FACIL: 50-389 St. Lucie Plant, Unit 2, Florida Power & Light Co.

SUBJECT: Forwards responses to Chemical Engineering Branch Questions 280.25-280.30 & Auxiliary Sys Branch Questions 410.39-410.46. Response will be incorporated in future FSAR amend. W/42 oversize drawings. Aperture Cards are available in PDR.

FLORIDA POWER & LIGHT COMPANY  
ST. LUCIE UNIT NO. 2  
FIRE HAZARD ANALYSIS

FLORIDA POWER & LIGHT  
 ST LUCIE 2  
 SHUTDOWN COOLING  
 ISOLATION

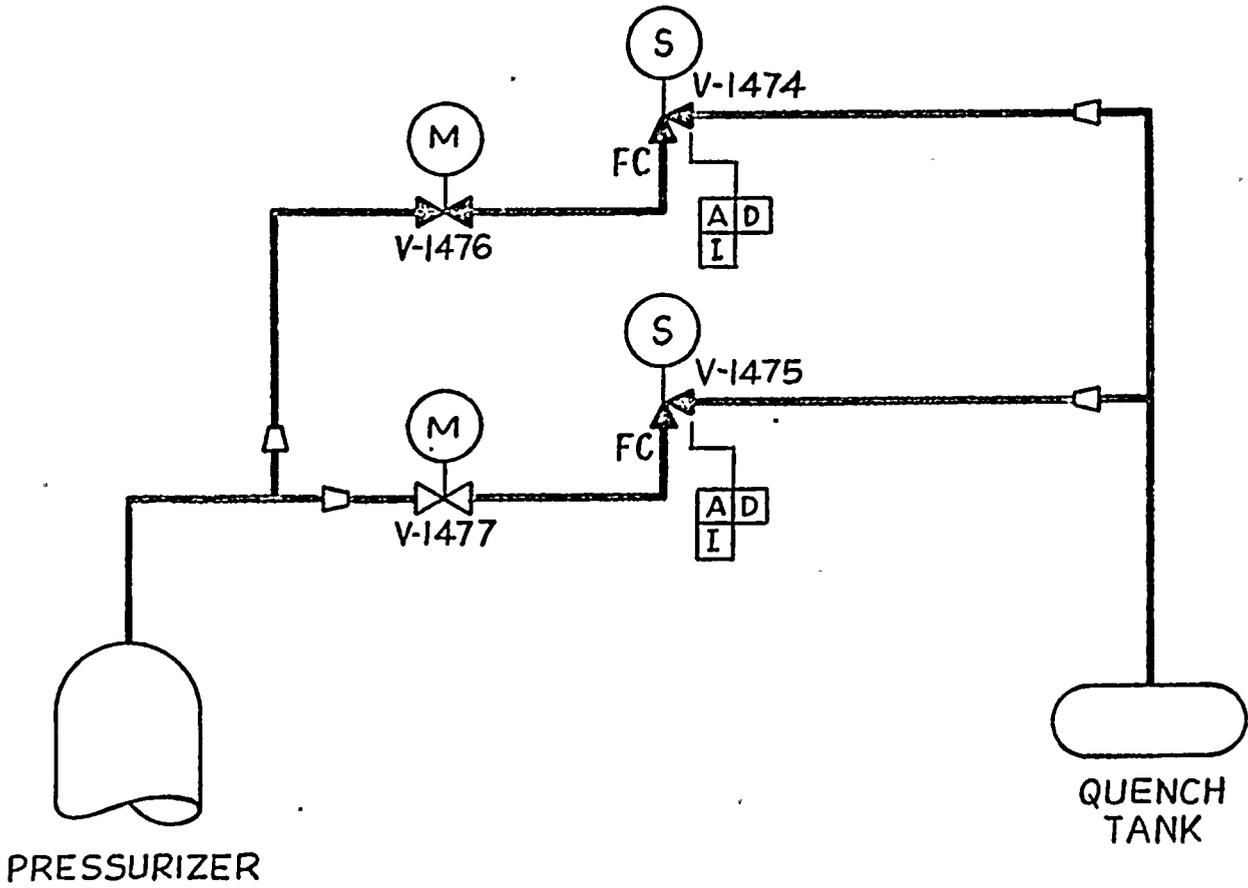
The residual heat removal system is generally a low pressure system that interfaces with the high pressure primary coolant system. To preclude a LOCA through this interface, we require compliance with the recommendations of Branch Technical Position RSB 5-1. Thus, this interface most likely consists of two redundant and independent motor operated valves with diverse interlocks in accordance with Branch Technical Position ICSB 3. These two motor operated valves and their associated cable may be subject to a single fire hazard. It is our concern that this single fire could cause the two valves to open resulting in a fire-initiated LOCA through the subject high-low pressure system interface. To assure that this interface and other high-low pressure interfaces are adequately protected from the effects of a single fire, we require the following information:

- a. Identify each high-low pressure interface that uses redundant electrically controlled devices (such as two series motor operated valves) to isolate or preclude rupture of any primary coolant boundary.
- b. Identify each device's essential cabling (power and control) and describe the cable routing (by fire area) from source to termination.
- c. Identify each location where the identified cables are separated by less than a wall having a three-hour fire rating from cables for the redundant device.

The Reactor Coolant System is isolated from the Low Pressure Safety Injection System by means of redundant locked-closed motor operated valves as shown on the attached figure. Valves V-3481 and 3652 are powered by the SA-Train while valves V-3480 and 3651 are powered by the SB-Train. Each of these valves is controlled by independent interlocks which prevent valve opening

when RCS pressure is 275 psig or above. The cross-tie valve (V-3545) is powered by the SAB-Train. In addition to these pressure interlocks Low Pressure Safety Injection is protected by relief valves (see FSAR Section 6.3.2.2.6.1) to prevent damage to this essential system. All cables essential to the proper operation of these valves are listed in Attachments 3 and 4 and are shown on the drawings that form a part of Attachment 6. In all cases where the cables for the redundant isolation valves are located in the same fire area one train of isolation valves will be protected within that area or relocated. This eliminates the possibility of a fire induced LOCA.
